**RE: Motorized Sun Solutions Addition  
4320 Ellison St NE  
Permanent Certificate of Occupancy – ACCEPTED  
Engineer’s Certification Date: 12/18/2025  
Engineer’s Stamp Date: 7/7/25  
Hydrology File: D17D065  
Case # HYDR-2025-00450**

Based on the Engineer’s Grading and Drainage Certification received 12/18/2025 and site visit on 12/23/2025, this letter serves as an approval from the Hydrology Section of the Engineer’s Certification for a Permanent Certificate of Occupancy for the building addition at 4320 Ellison St NE to be issued by the Building and Safety Division.

SHEET TITLE  
**GRADING & DRAINAGE PLAN**

SHEET NUMBER  
**CG-101**

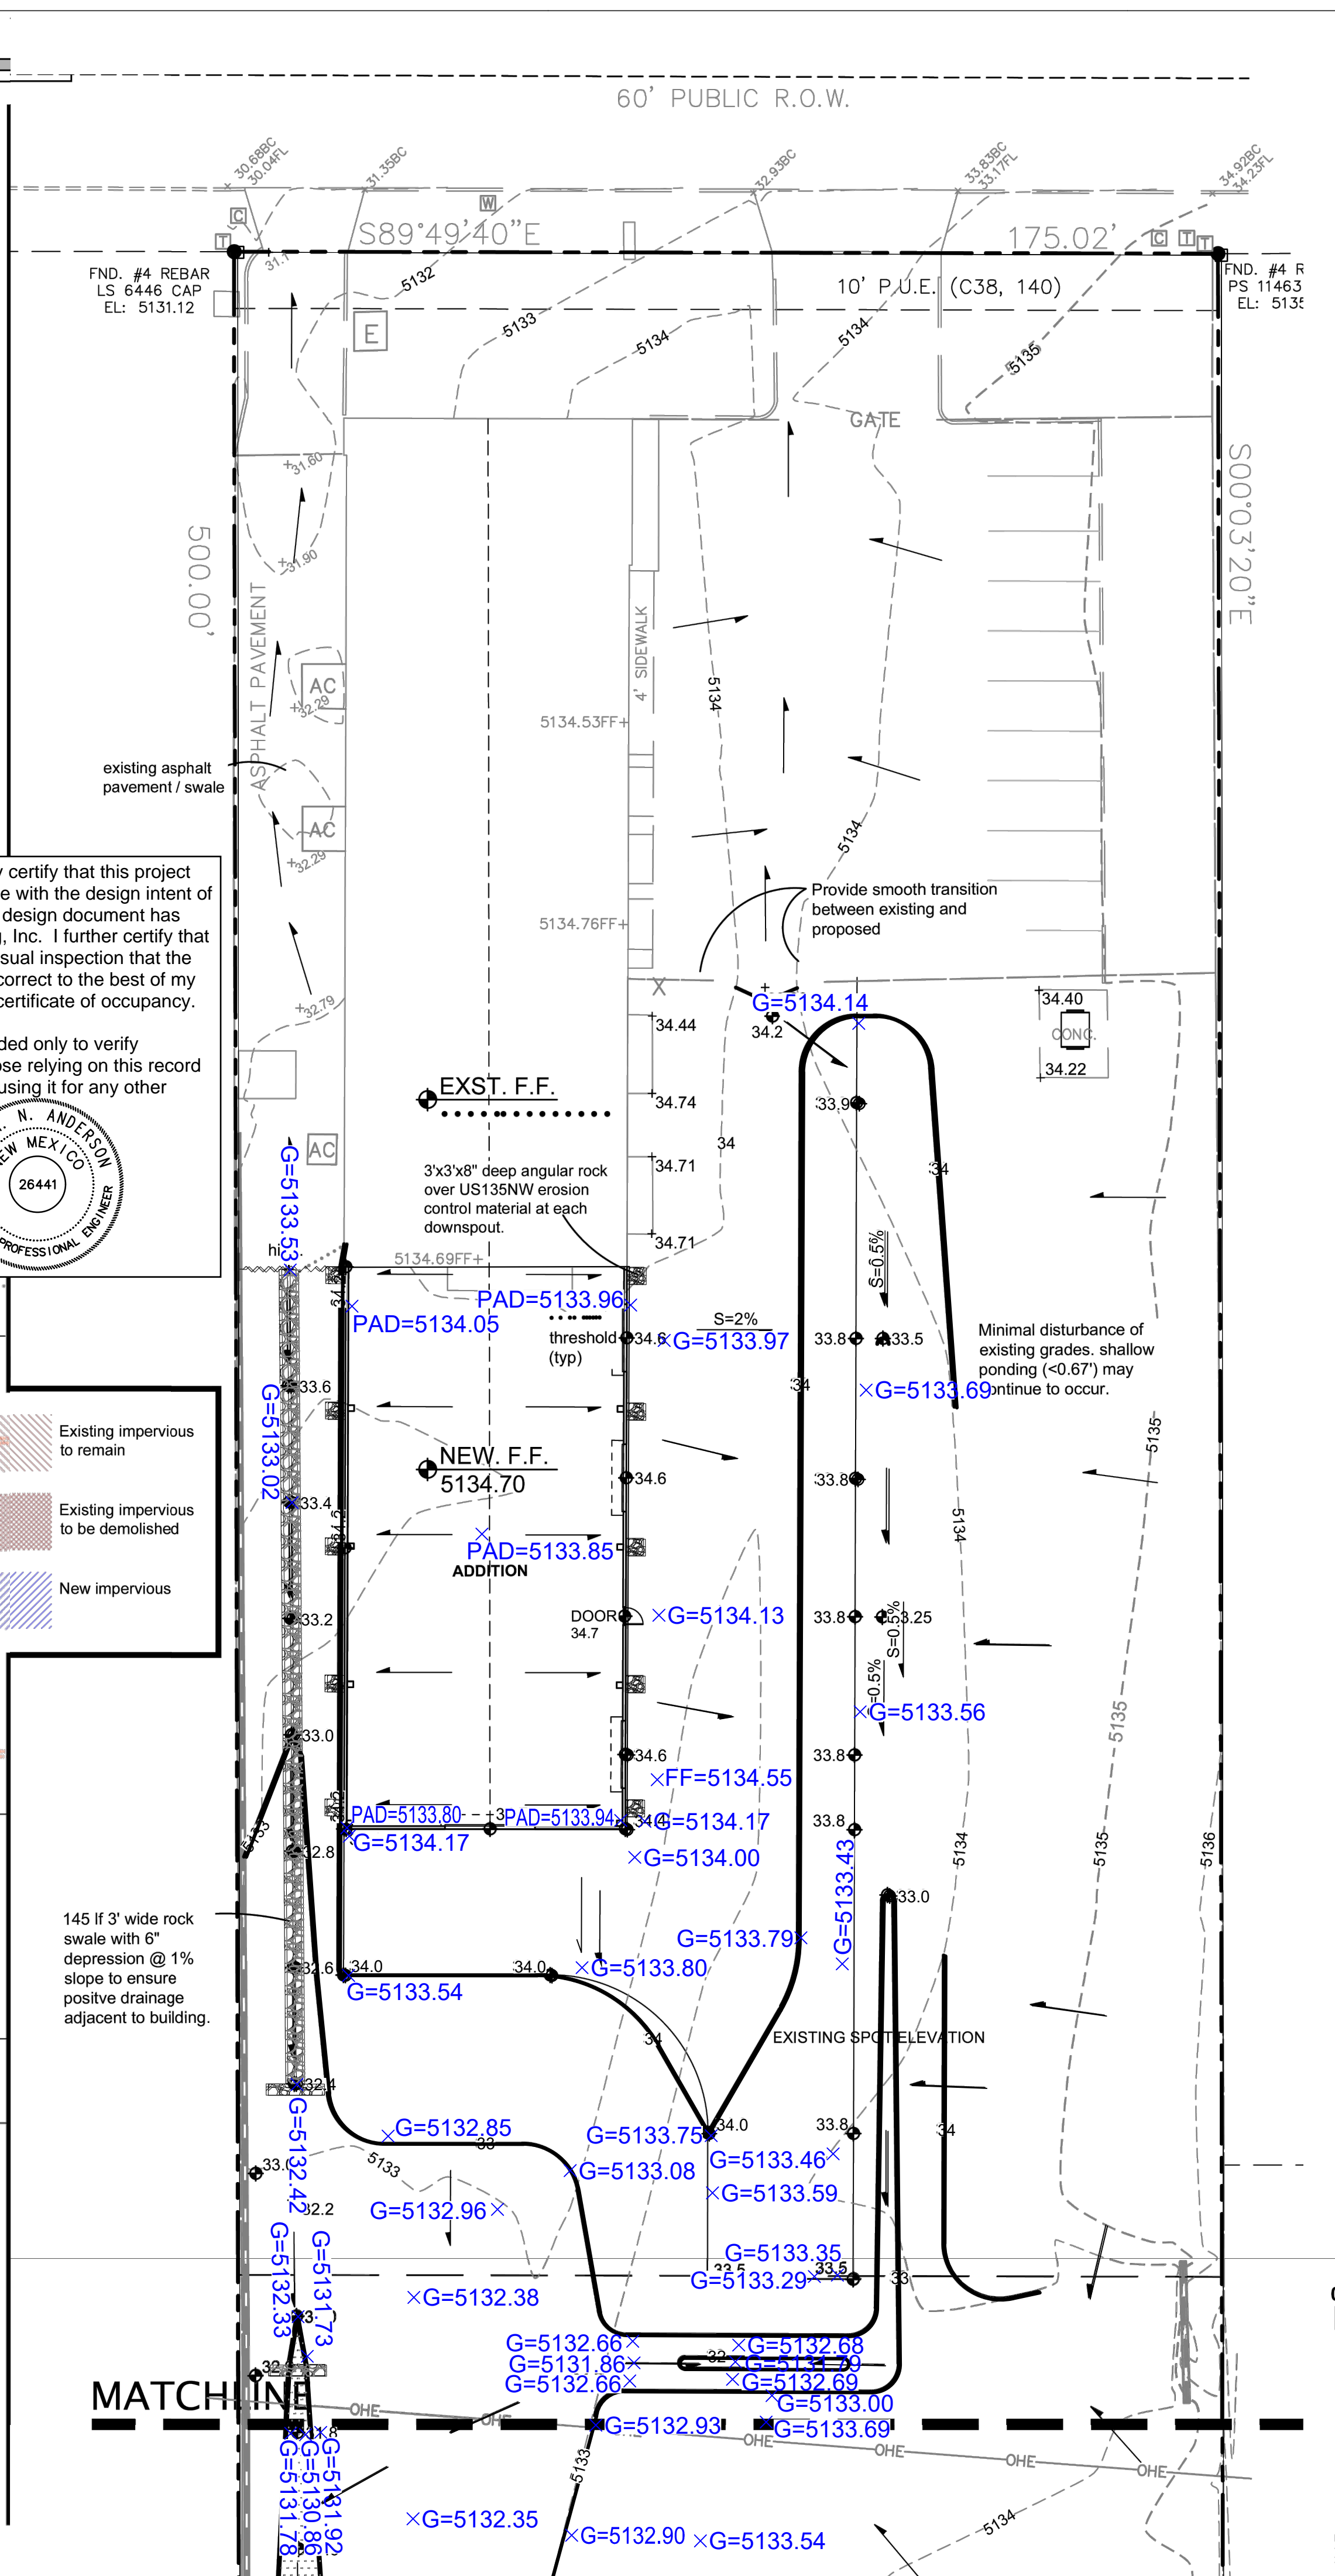
COMMENTS FROM AMAFCA - 2025 06-20  
 This site is allowed free discharge, so other than the WQ volume this site does not need to have additional detention.

DRAINAGE CHANNEL PROTECTION:  
 Based on site observation, the current condition of the channel conveys site discharge to the existing dip section with no indication of erosion or undermining of the channel edge.

Future improvements on this property which increases the discharge to the channel may require improvements from property line to channel to ensure flows enter channel at dip-section.
